CHANGE ORDER NO. 1
EXHIBIT 'A'

| CHECKED | CH | ROADS & TRANSPORTATION | | | GUIBERSON ROAD CULVERT REPLACEMENT AT MP 5.97 | DRAWING NO. | 116505A |

**SPECIAL PROVISIONS FOR CONTRACT CHANGE ORDER NO. 1
CULVERT REPLACEMENT AT GUIBERON RD. MP 5.97****1000 GENERAL REQUIREMENTS****1000-1 DESCRIPTION OF WORK**

Work under this Contract Change Order (CCO) No. 1 consists of replacement of reinforced concrete pipe on Guiberson Road MP 5.97. This work includes public access and notice, traffic control and construction signing, removal of existing structures, structure excavation and backfill, bracing and shoring, 72" reinforced concrete pipe, headwall with straight wingwalls (upstream and downstream), reinforced concrete apron, debris barrier, 2-sack cement slurry, 1-ton rip rap apron (upstream and downstream), 8" thick AC pavement repair, and appurtenant work.

PIPE CULVERT PLAN VIEW AT MP 5.91
SCALE = 1" = 10'

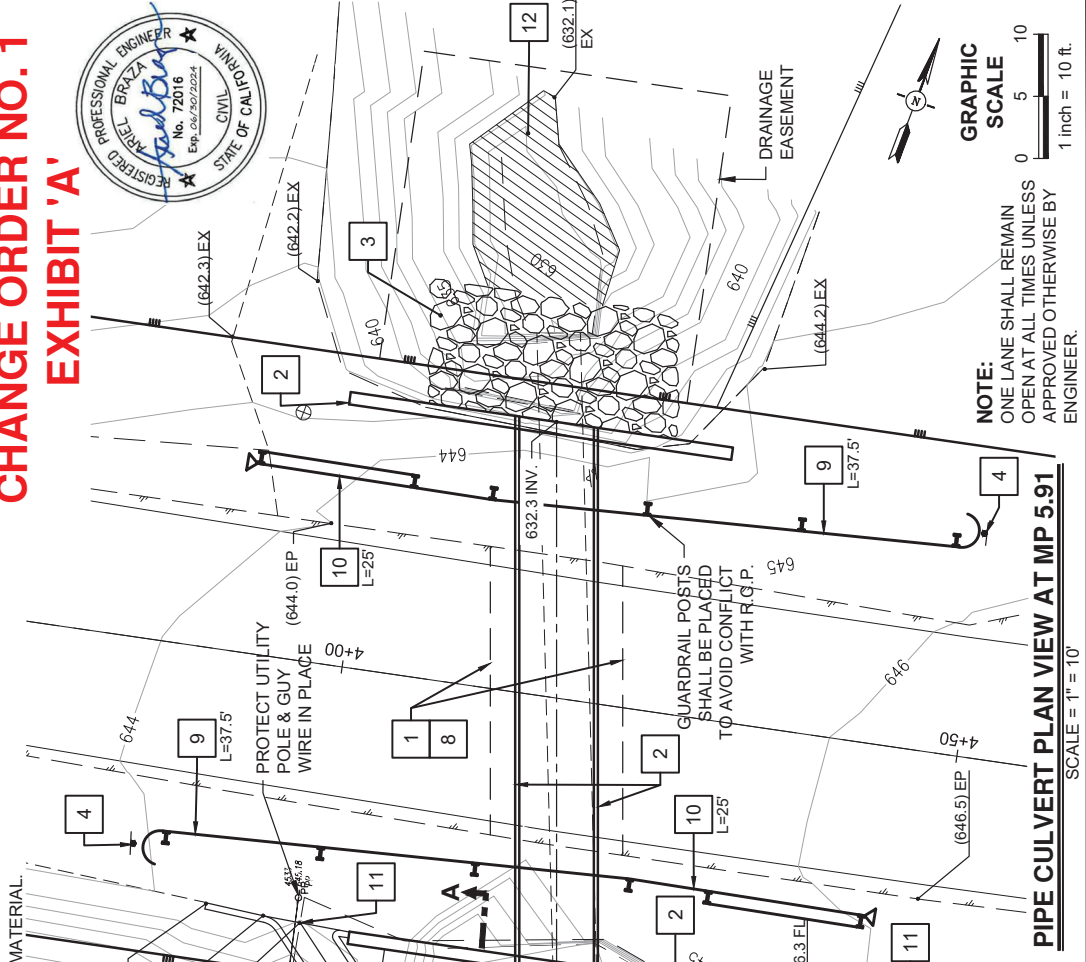
- 1 SAWCUT AND REMOVE EXISTING PAVEMENT, HEADWALLS, CULVERTS, GUARDRAIL, POSTS AND EXCESS MATERIAL.
- 2 INSTALL CLASS II 72" R.C.P. CULVERT AND HEADWALL. CONSTRUCT PIPE CULVERT HEADWALL PER CALTRANS STD. PLAN RSP D90. H=PER PLAN. SEE CULVERT PLAN HEREON. SEE CULVERT PROFILE AND DETAILS SHOWN ON SHEET 4B FOR MORE INFORMATION.

- 3 CONSTRUCT 1-TON RIP-RAP WITH SYNTHETIC FILTER FABRIC, 20' L x 10' W x 4.25' D (DOWNSTREAM) AND 4' W x 4.25' D (ADJACENT TO BOLLARD FOOTING UPSTREAM).

- 4 PLACE OBJECT MARKER TYPE L-1(CA) WITH MILEPOST MARKING PER OBJECT MARKER DETAIL SHOWN ON SHEET 4D.
- 5 INSTALL CONCRETE BOLLARDS AND BOLLARD FOOTING PER DEBRIS BARRIER DETAIL SHOWN ON SHEET 4C. CONTRACTOR SHALL FORM BOLLARD CONCRETE FOOTING WITH 90% OF MAXIMUM DENSITY COMPACTION UNDER FOOTING & BACKFILL. BOLLARDS SHALL BE 10 FOOT LONG, WITH 7 FOOT ABOVE THE TOP OF CONCRETE FOOTING. 6" DIAMETER, SCHEDULE 40 STEEL PIPE, SET 5'-0" O.C. BOLLARDS SHALL BE PLACED IN TWO STAGGERED ROWS 2'-0" O.C. A PART. BOLLARDS SHALL BE FILLED SOLID WITH CONCRETE. OUTSIDE OF BOLLARDS SHALL BE KEPT CLEAN.

- 7 CONSTRUCT 10" THICK REINFORCED CONCRETE APRON AT R.C.P. INLET. SEE SECTIONS A-A AND B-B ON SHEET 4C (646.0) EX FOR MORE DETAILS. APRON MAY BE FORMED OR SHOTCRETE, PER SPECIFICATIONS.

- 8 FOR CULVERT TRENCH BACKFILL SEE TRENCHING DETAILS SHOWN ON SHEET 4D.
- 9 INSTALL FLARED TERMINAL SYSTEM END TREATMENT TYPE SRT-350 PER CALTRANS STD. PLAN RSP A77P1, TYPE 11B WITH STEEL POSTS PER STD. PLAN A77N2. INSTALL GUARDRAIL BUTTERFLY REFLECTORS @ 12.5 FEET INTERVALS.

- 10 INSTALL IN-LINE TERMINAL SYSTEM END TREATMENT TYPE SKT-350 PER CALTRANS STD. PLAN RSP A77P1, TYPE 11A WITH STEEL POSTS PER STD. PLAN A77N2. INSTALL GUARDRAIL BUTTERFLY REFLECTORS @ 12.5 FEET INTERVALS.

- 11 INSTALL 2' WIDE CONCRETE SWALE PER DETAIL SHOWN ON SHEET 4D.
- 12 PLACE ±2' DEPTH OF NATIVE SOIL COMPACT TO 90% COMPACTION. MAINTAIN POSITIVE FLOW DOWNSTREAM.

PIPE CULVERT PROFILE AT MP 5.91

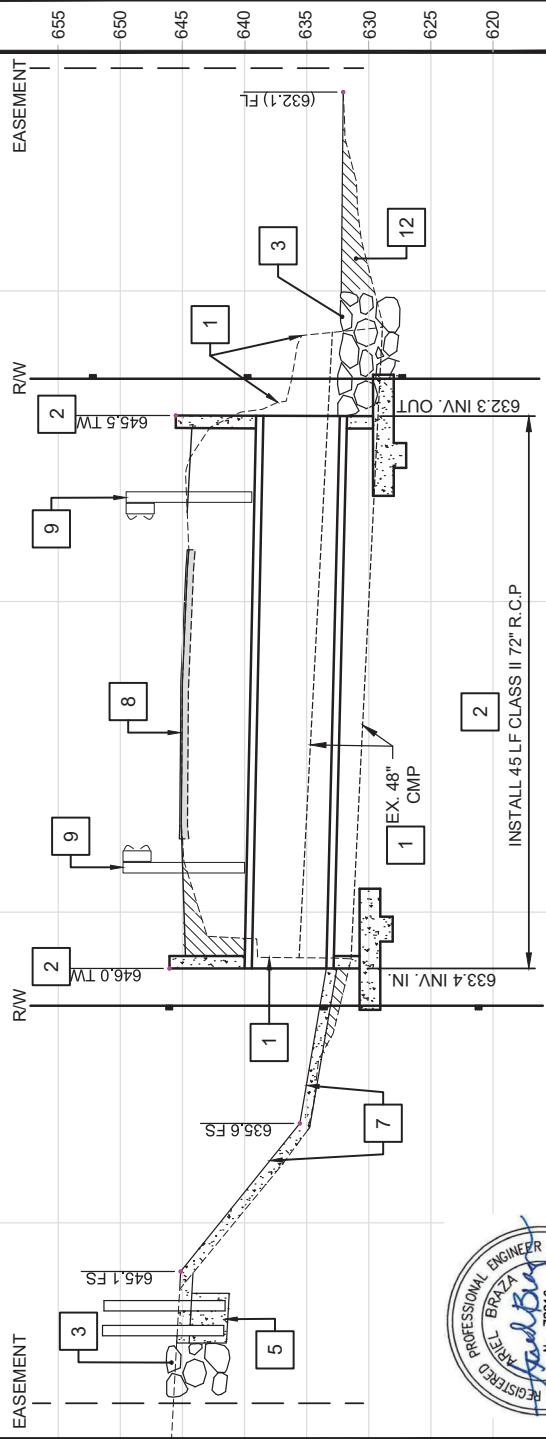
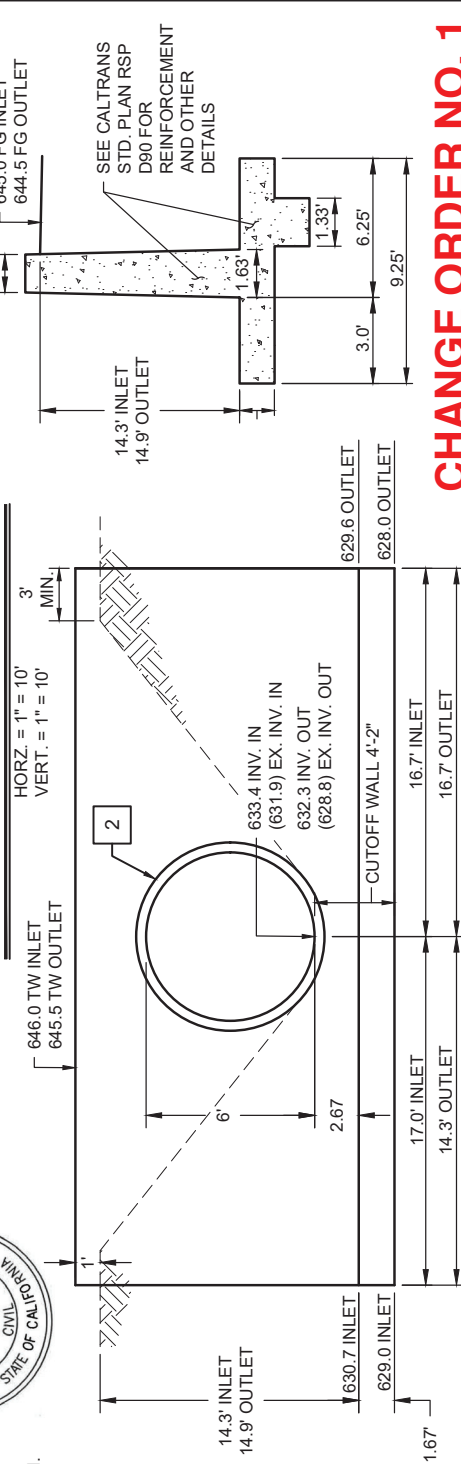
- 1 SAWCUT AND REMOVE EXISTING PAVEMENT, HEADWALLS, CULVERTS, GUARDRAIL, POSTS AND EXCESS MATERIAL.
- 2 INSTALL CLASS II 72" R.C.P. CULVERT AND HEADWALL. CONSTRUCT PIPE CULVERT HEADWALL PER CALTRANS STD. PLAN RSP D90. H=PER PLAN. SEE CULVERT PLAN ON SHEET 4A. SEE CULVERT PROFILE AND DETAILS HEREON.

- 3 CONSTRUCT 1-TON RIP-RAP WITH SYNTHETIC FILTER FABRIC, 20' L X 10' W X 4.25' D (DOWNSTREAM) AND 4' W X 4.25' D (ADJACENT TO BOLLARD FOOTING UPSTREAM).

- 5 INSTALL CONCRETE BOLLARDS AND BOLLARD FOOTING PER DEBRIS BARRIER DETAIL SHOWN ON SHEET 4C. CONTRACTOR SHALL FORM BOLLARD CONCRETE FOOTING WITH 90% OF MAXIMUM DENSITY COMPACTION UNDER FOOTING & BACKFILL. BOLLARDS SHALL BE 10 FOOT LONG, WITH 7 FOOT ABOVE THE TOP OF CONCRETE FOOTING. 6" DIAMETER, SCHEDULE 40 STEEL PIPE, SET 5'-0" O.C. BOLLARDS SHALL BE PLACED IN TWO STAGGERED ROWS 2'-0" O.C. A PART. BOLLARDS SHALL BE FILLED SOLID WITH CONCRETE. OUTSIDE OF BOLLARDS SHALL BE KEPT CLEAN.

- 7 CONSTRUCT 10" THICK REINFORCED CONCRETE APRON AT R.C.P. INLET. SEE SECTIONS A-A AND B-B ON SHEET 4C FOR MORE DETAILS. APRON MAY BE FORMED OR SHOTCRETE, PER SPECIFICATIONS.

- 8 FOR CULVERT TRENCH BACKFILL SEE TRENCHING DETAILS SHOWN ON SHEET 4D.
- 9 INSTALL FLARED TERMINAL SYSTEM END TREATMENT TYPE SRT-350 PER CALTRANS STD. PLAN RSP A77P1, TYPE 11B WITH STEEL POSTS PER STD. PLAN A77N2. INSTALL GUARDRAIL BUTTERFLY REFLECTORS @ 12.5 FEET INTERVALS.

- 12 PLACE ±2' DEPTH OF NATIVE SOIL COMPACT TO 90% COMPACTION. MAINTAIN POSITIVE FLOW DOWNSTREAM

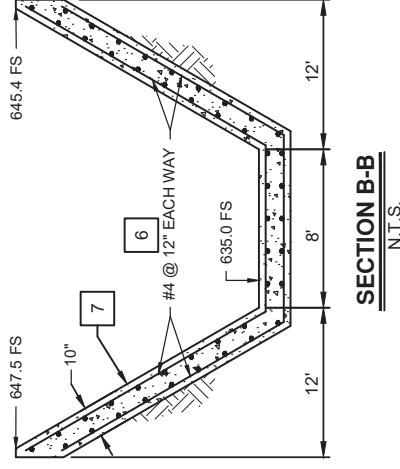
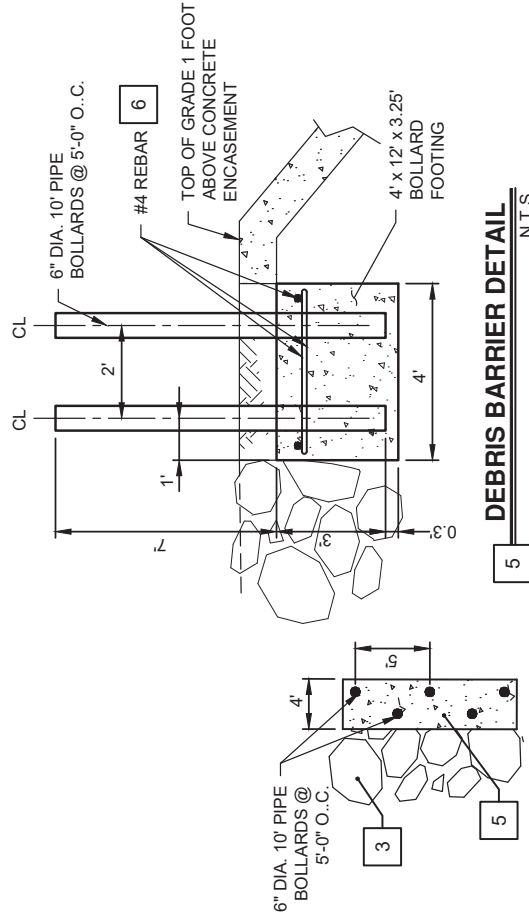
| 2 | INSTALL CLASS II 72" R.C.P CULVERT AND HEADWALL. CONSTRUCT PIPE CULVERT HEADWALL PER CALTRANS STD. PLAN RSP D90. H=PER PLAN. SEE CULVERT PLAN ON SHEET 4A. SEE CULVERT PROFILE AND DETAILS SHOWN ON SHEET 4B FOR MORE INFORMATION. |
| 3 | CONSTRUCT 1-TON RIP-RAP WITH SYNTHETIC FILTER FABRIC. 20' L X 10' W X 4.25' D (DOWNSTREAM) AND 4' W X 4.25' D (ADJACENT TO BOLLARD FOOTING UPSTREAM). |
| 5 | INSTALL CONCRETE BOLLARDS AND BOLLARD FOOTING PER DEBRIS BARRIER DETAIL SHOWN HEREON. CONTRACTOR SHALL FORM BOLLARD CONCRETE FOOTING WITH 90% OF MAXIMUM DENSITY COMPACTION UNDER FOOTING & BACKFILL. BOLLARDS SHALL BE 10 FOOT LONG, WITH 7 FOOT ABOVE THE TOP OF CONCRETE FOOTING, 6" DIAMETER, SCHEDULE 40 STEEL PIPE, SET 5'-0" O.C. BOLLARDS SHALL BE PLACED IN TWO STAGGERED ROWS 2'-0" O.C. A PART, BOLLARDS SHALL BE FILLED SOLID WITH CONCRETE. OUTSIDE OF BOLLARDS SHALL BE KEPT CLEAN. |
| 6 | #4 REBAR SHALL HAVE 2" CONCRETE COVER. |
| 7 | CONSTRUCT 10" THICK REINFORCED CONCRETE APRON AT R.C.P. INLET. SEE SECTIONS A-A AND B-B HEREON. APRON MAY BE FORMED OR SHOTCRETE. PER SPECIFICATIONS. |

SHEET 4D
OF 4
DRAWING NO.
116505D

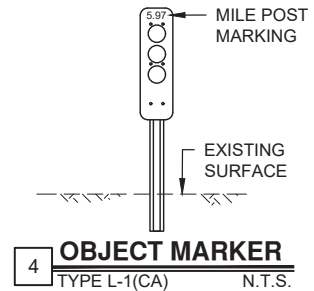
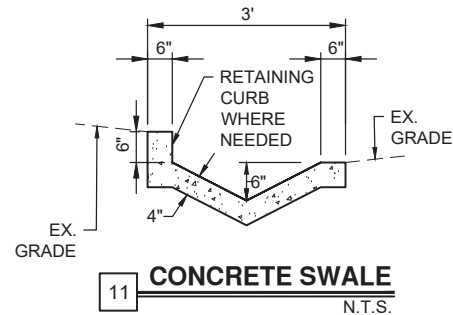
11 | INSTALL 2' WIDE CONCRETE SWALE PER DETAIL SHOWN HEREON.
